# CITY PLANNING DEPARTMENT

## Memorandum – Unified Development Review

**To:** City Plan Commission  
**From:** Jonas U. Bruggemann, MSCRP | Senior Planner  
**Date:** May 7, 2024  
**RE:** Brewed Awakenings: 1234 Oaklawn Avenue – Assessors Plat 15/1, Lot 1015  
**Application for Unified Development Review for a Preliminary Plan**

# EXISTING CONDITIONS PLAN

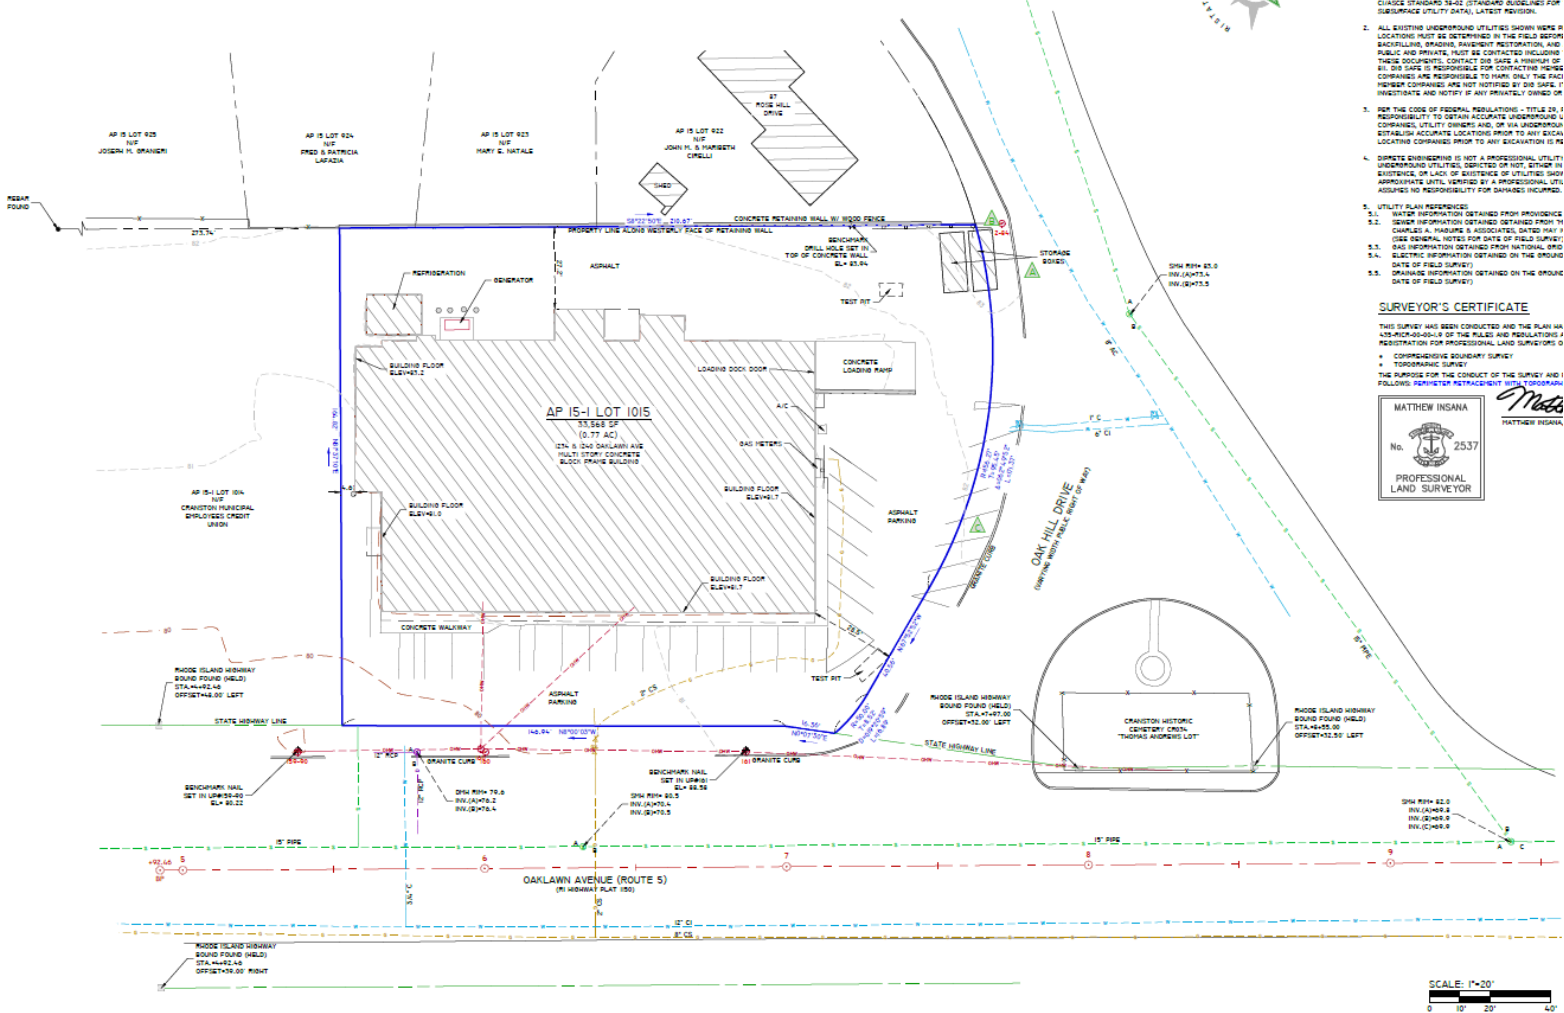
- d. Providence Water Supply Board: Although PWSB hasn't responded at this time, the existence of a 6" water supply line on the Existing Conditions Plan indicates existing service.
